GeoSolve Ref: 240480.03
3 December 2025

Surface Water and River Engineering Assessment Memo Bendigo-Ophir Gold Project Fast-Track Application Assessment

Figure 3: Underdrain bypass pipe as shown on page 25 of Appendix L (pdf page 156) of document B.06C

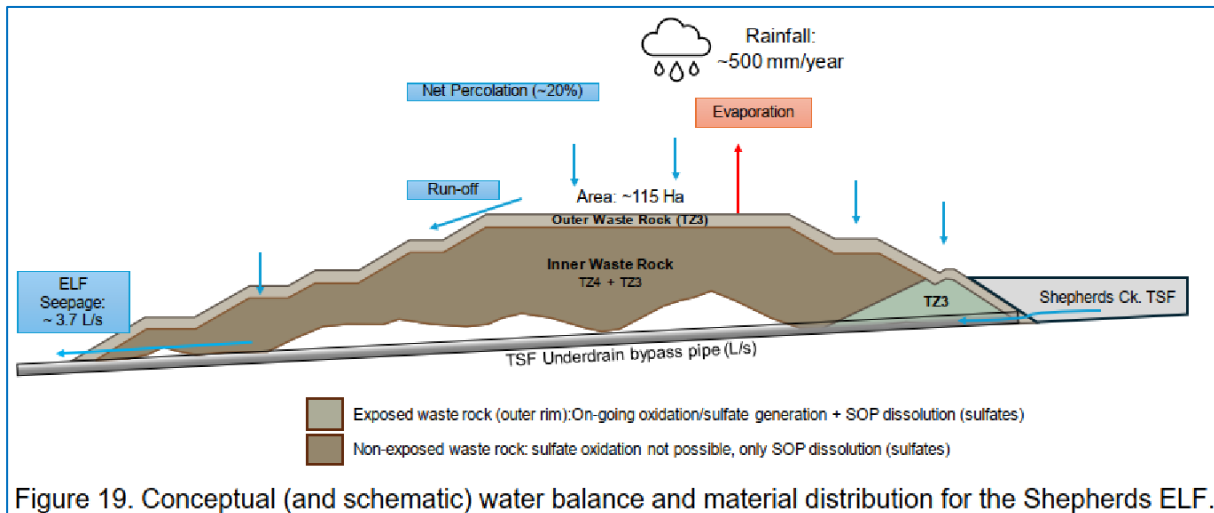
- Document B.04 references the Tailings Storage Facility (TSF) dam design documents prepared by Mine Waste Management (document B.06, including appendices documents B.06 A-C), and GeoSolve has searched these documents for references to the tailings dam. Those documents show that there will be an underdrain bypass pipe under the tailings dam (see Figure 3 below), and it is unclear whether this has been taken into account in Kōmanawa Solutions' estimate of the 50-60 years it will take for the tailings dam to fill. **It is recommended that Kōmanawa Solutions and Mine Waste**

Management's design & calculation works for the tailings dam are confirmed to be co-ordinated, as this will also affect factors such as dam safety, contaminant transport, monitoring and maintenance and more. It is requested that the applicant confirms this has/will be performed, including details.
